ZU1 SYSTEM BLOCK DIAGRAM

PROJECT : ZU1
Quanta Computer Inc.

Size	Document Number	Rev
	CLK_GEN/CK505	3B
Date:	Tuesday, April 10, 2007	Sheet 2 of 39

PROJECT : ZU1 Quanta Computer Inc.	PROJECT : ZU1	APPROVE BY : James Lu	DRAWING BY:Barry Lee	Stage: A1	CHANGE LIST SHEET 1
	MB ASSY'S P/N : 31ZU1MB0000	PROJECT LEADER:Jack Wu	DOCUMENT NO:	DATE :2006/12/09

LVDS

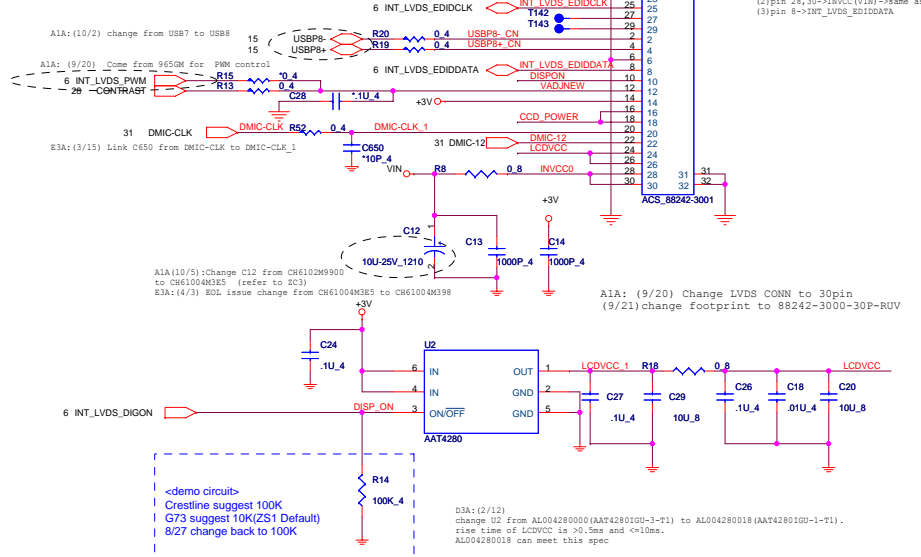
B1C: (11/20)
 (1) change PWM control from 9650M to EC
 (2) Short R7, unstuff C28 (L-C filter will impact PWM signal)
 (3)stuff R13, no stuff R15
 C2A: (12/28) EMI request: reserve I-C footprint for debug use (R52,C650)
 D3A: (2/12) Stuff R15, Change PWM control from EC to 9650M
 D3A: (2/14) Acer inform no support DPST in C build, remove R15

Size	Document Number	Rev
	1394(TSB43AB23)	38
Date:	Tuesday, April 10, 2007	Sheet 25 of 39

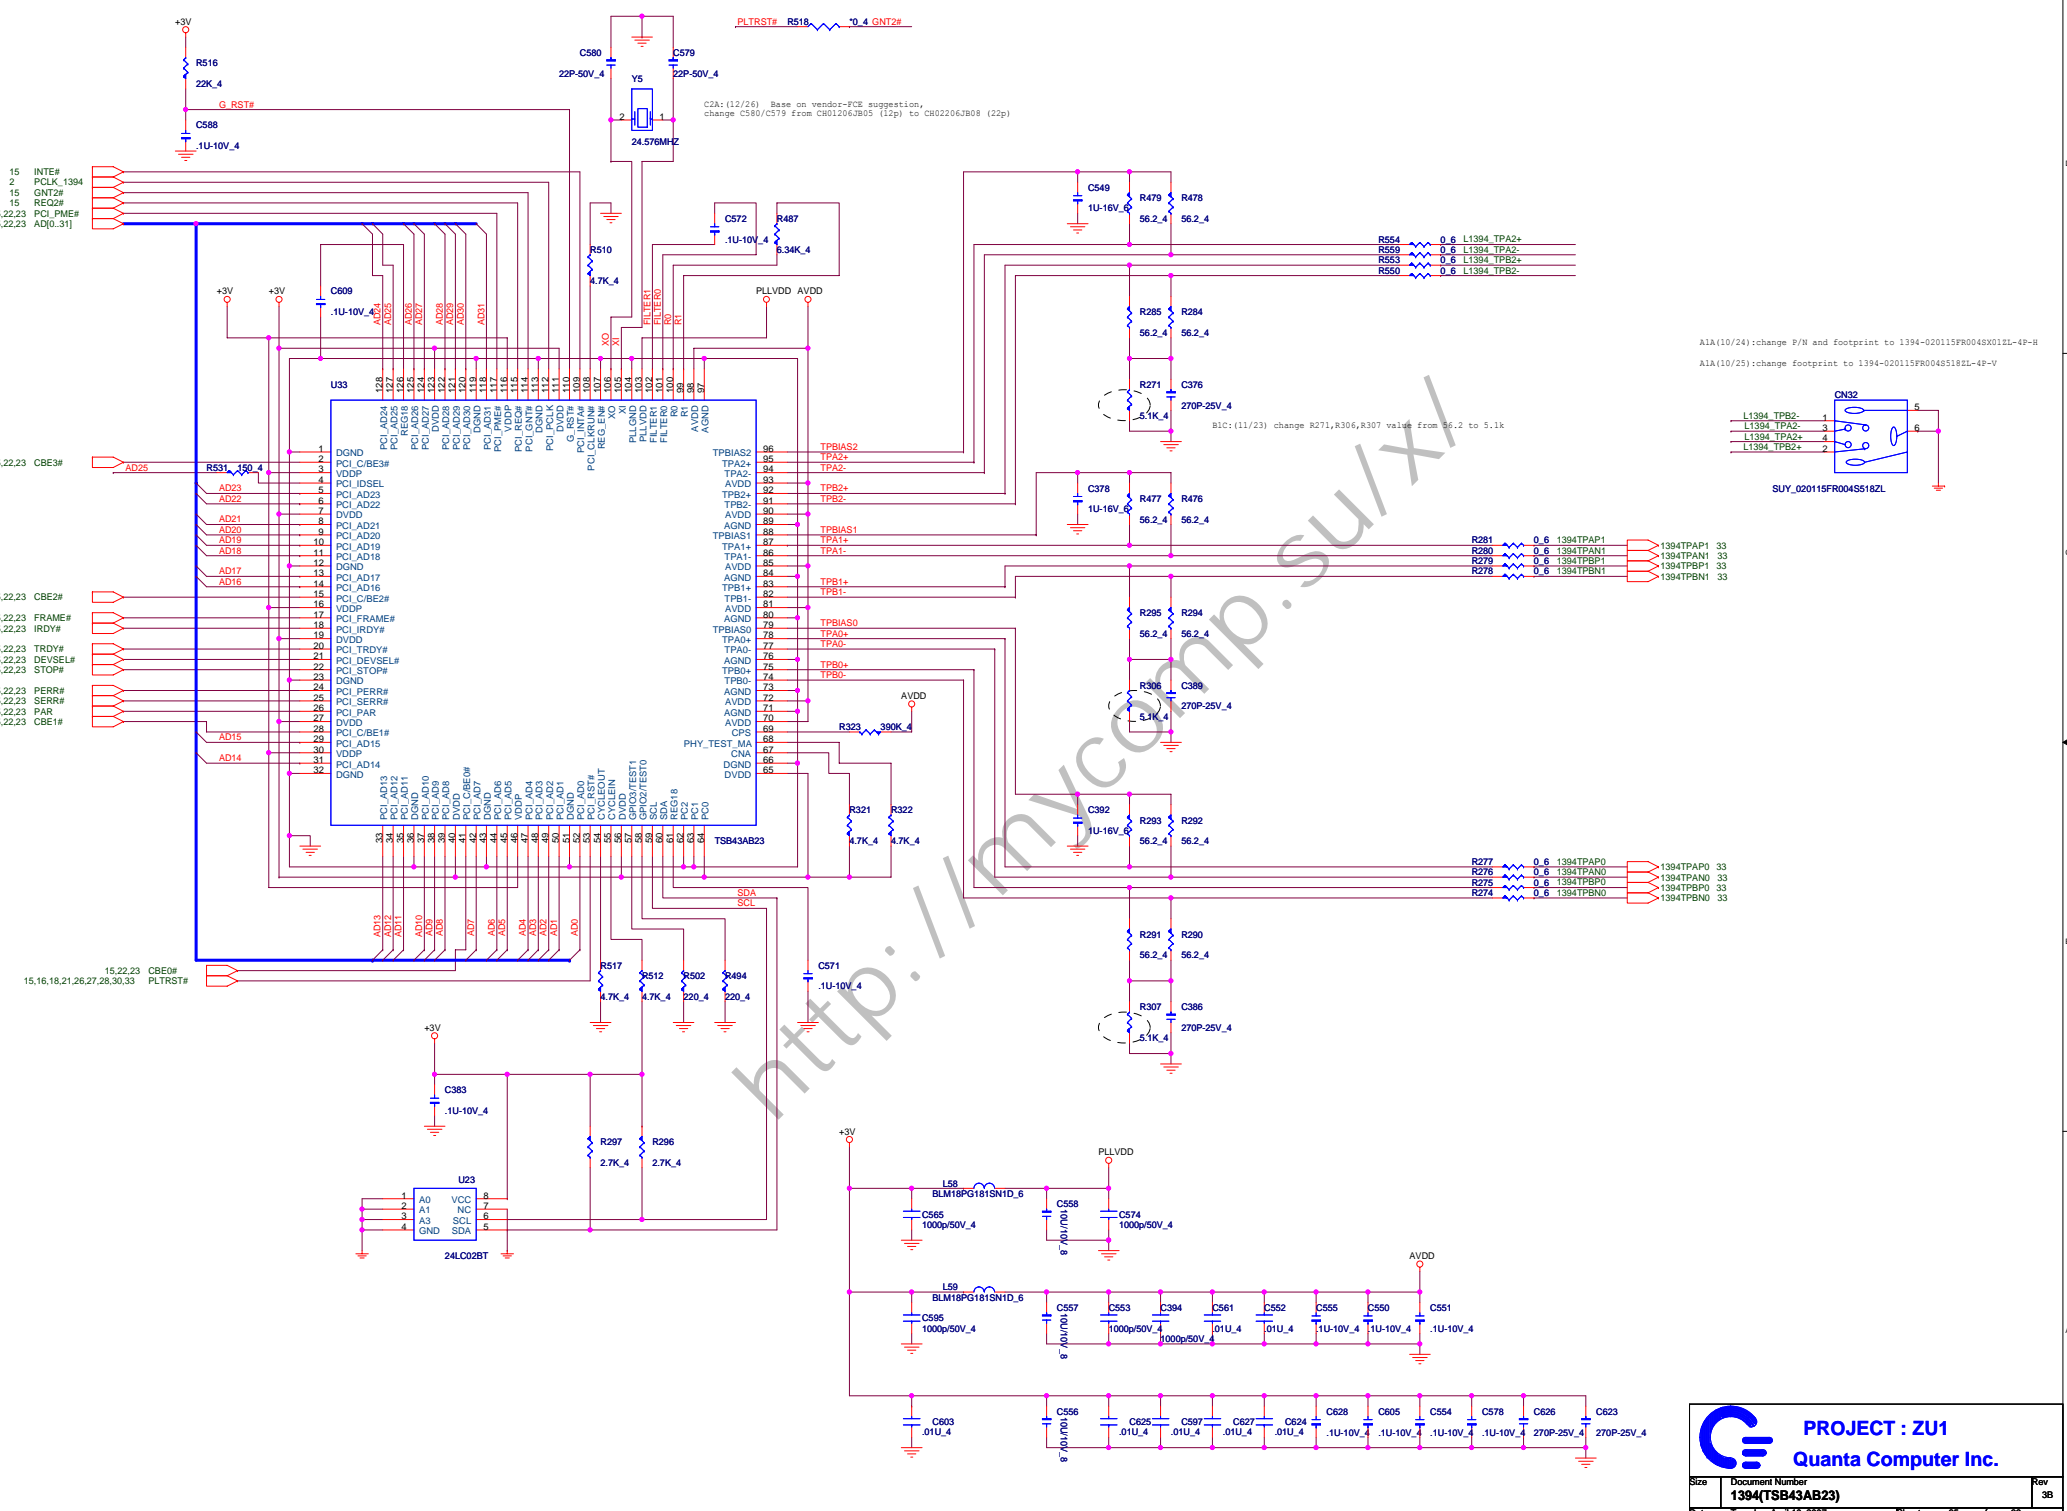
A1A(10/24):change P/N and footprint to 1394-020115FR0046X012L-4P-H
 A1A(10/25):change footprint to 1394-020115FR0046S182L-4P-V

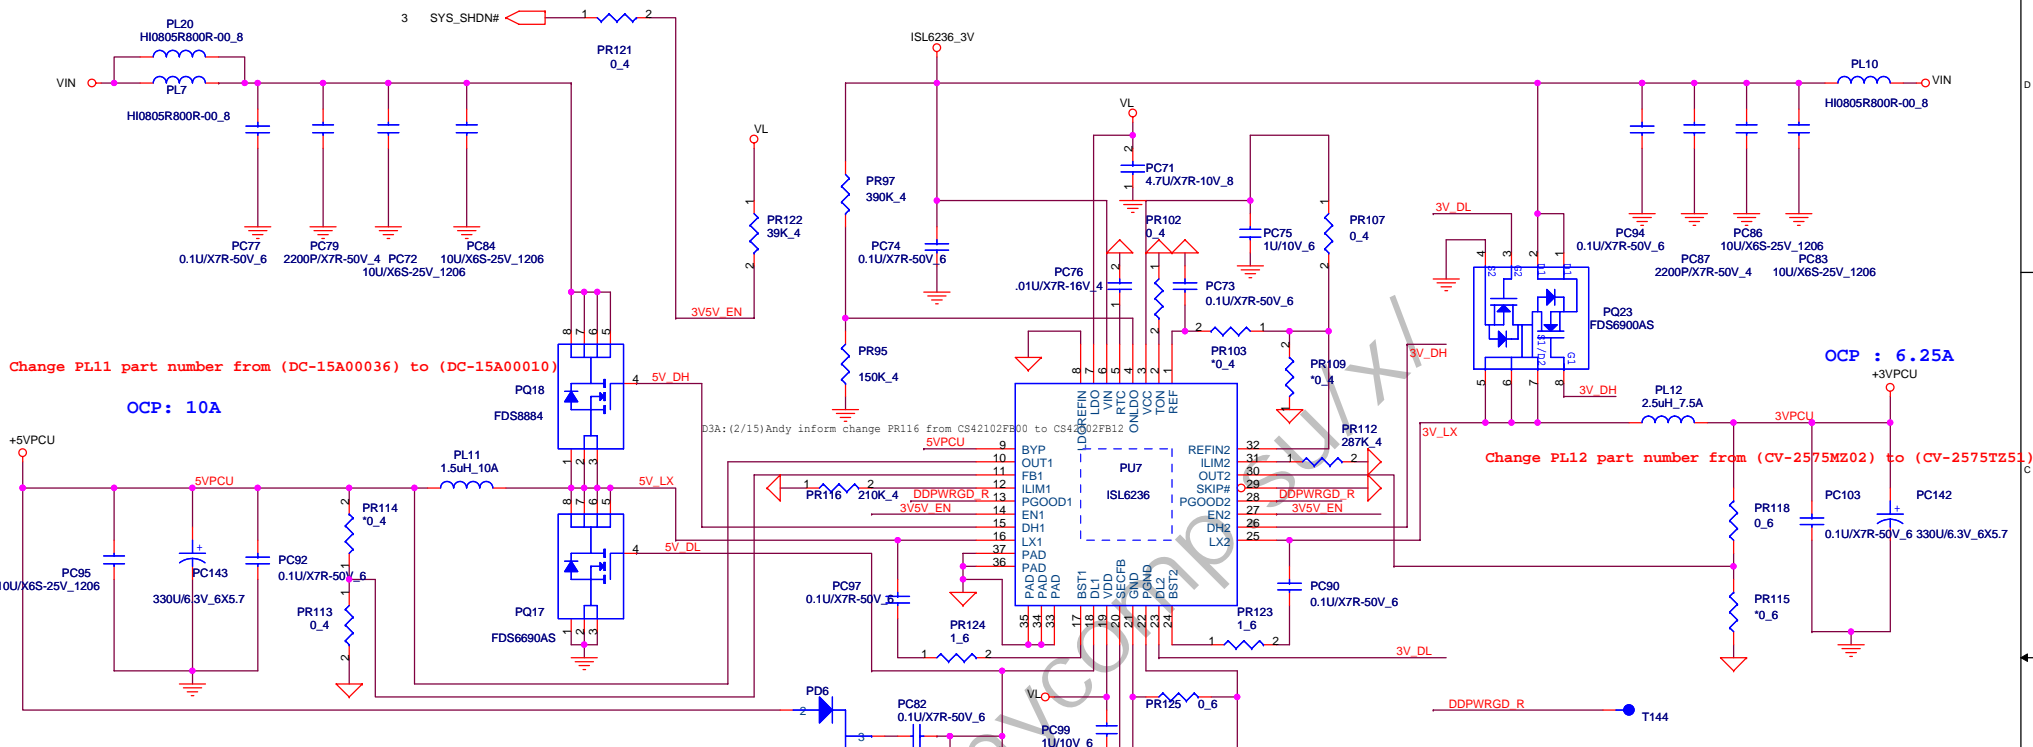
Change PL11 part number from (DC-15A00036) to (DC-15A00010)
OCP : 10A

OCP:10A
 $L(\text{ripple current}) = (19-5) * 5 / (1.5u * 0.4M * 19) \sim 6A$
 $I_{ocp} = 10 - (6/2) = 7A$
 $V_{th} = 7A * 15m\Omega = 105mV$
 $R(I_{lim}) = (105mV * 10) / 5uA \sim 210K$

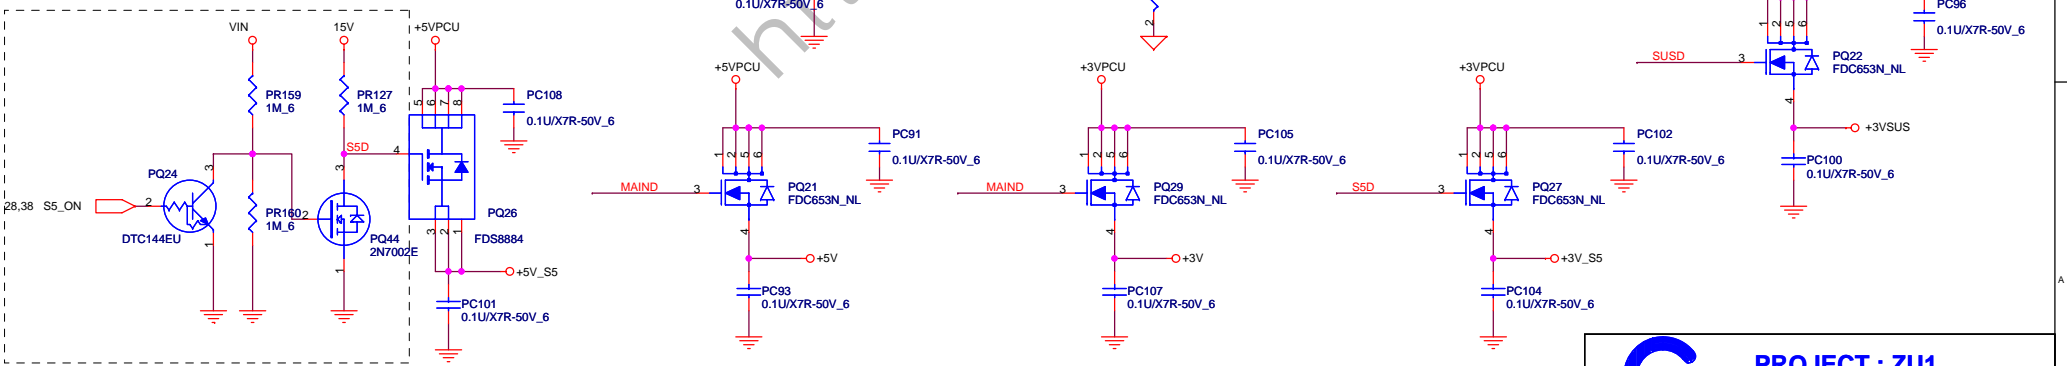
Change PL12 part number from (CV-2575MZ02) to (CV-2575TZ51)
OCP : 6.25A

OCP:6.25A
 $L(\text{ripple current}) = (19-3.3) * 3.3 / (2.5u * 0.5M * 19) \sim 2.18A$
 $I_{ocp} = 6.25 - (2.18/2) = 5.16A$
 $V_{th} = 5.16A * 28m\Omega = 145mV$
 $R(I_{lim}) = (145mV * 10) / 5uA \sim 294K$

C2A: (12/10) change S5_ON control circuit
 B1C: (11/29) Change PQ26 from FDS6690AS (BAM66900022) to FDS8884 (BAM88840006)

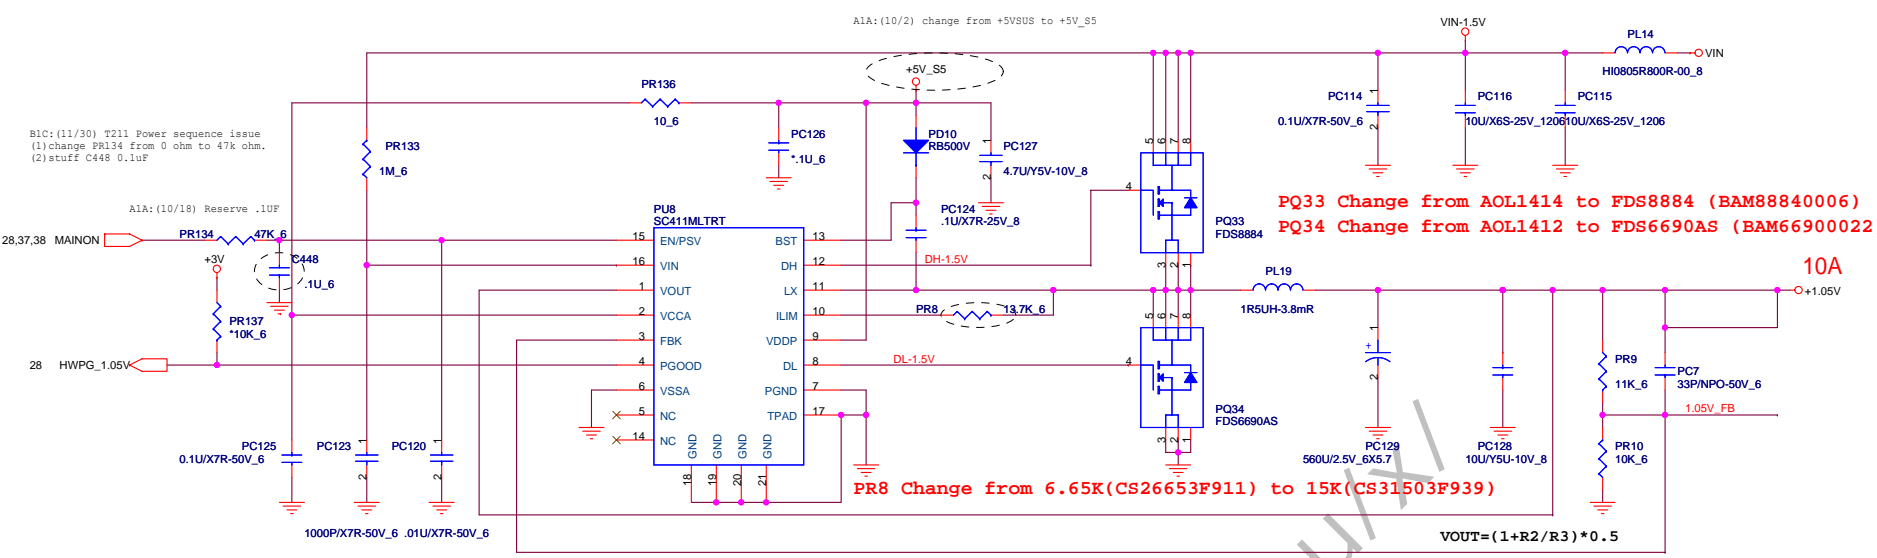
B1C: (11/30) T211 Power sequence issue
 (1) change PR134 from 0 ohm to 47k ohm.
 (2) stuff C448 0.1uF

A1A: (10/18) Reserve .1uF

A1A: (10/2) change from +5VSUS to +5V_S5

Size	Document Number	Rev
	Charger (ISL6251)	3B
Date:	Tuesday, April 10, 2007	Sheet 39 of 39

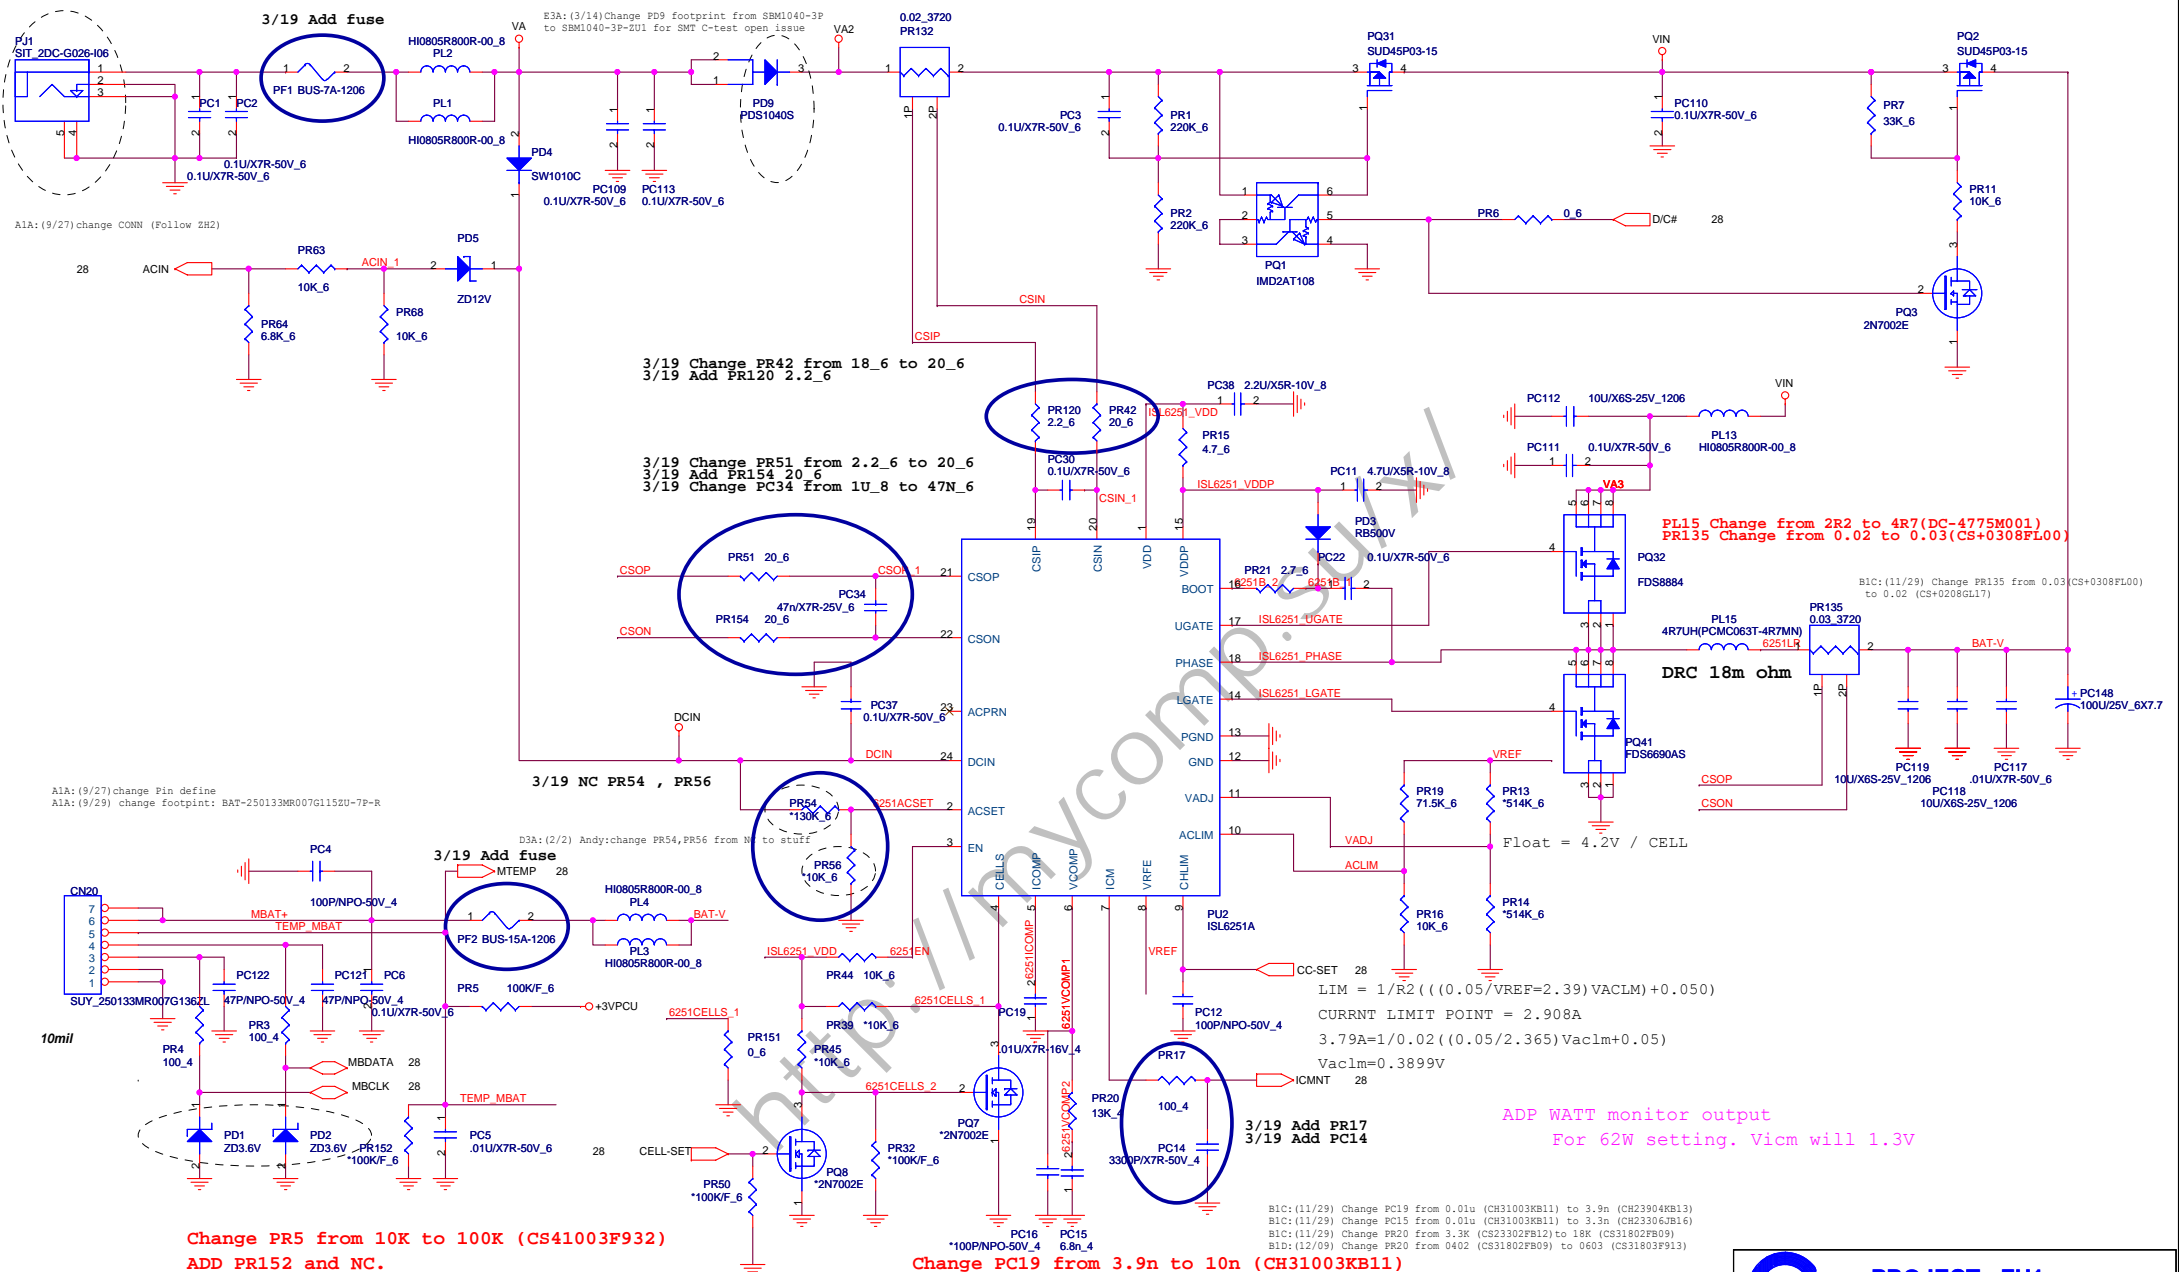
B1C:(12/11) Change PR86 from 8.25K (CS28253F938) to 14K (CS31403F919)

B1C:(11/29) Change PR86 from 12K (CS31203F911) to 8.25K (CS28253F938)

C2A:(12/28) EMI request: DEL PR120 2.2ohm(CS-2203F911), stuff PC98

3/19 Change PR42 from 18_6 to 20_6
3/19 Add PR120 2.2_6

3/19 Change PR51 from 2.2_6 to 20_6
3/19 Add PR154 20_6
3/19 Change PC34 from 1U_8 to 47N_6

PL15 Change from 2R2 to 4R7(DC-4775M001)
PR135 Change from 0.02 to 0.03(CS+0308FL00)

B1C: (11/29) Change PR135 from 0.03 (CS+0308FL00) to 0.02 (CS+0208G117)

Change PR5 from 10K to 100K (CS41003F932)
ADD PR152 and NC.

Change PC19 from 3.9n to 10n (CH31003KB11)
Change PC15 from 3.3n to 6.8n (CH26804KB18)
Change PR20 from 18K/F to 13K/F (CS31302FB19)

B1C: (11/29) Change PC19 from 0.01u (CH31003KB11) to 3.9n (CH23904KB13)
B1C: (11/29) Change PC15 from 0.01u (CH31003KB11) to 3.3n (CH23306B16)
B1C: (11/29) Change PR20 from 3.3K (CS23302FB12) to 18K (CS31802FB09)
B1D: (12/09) Change PR20 from 0402 (CS31802FB09) to 0603 (CS31803F913)
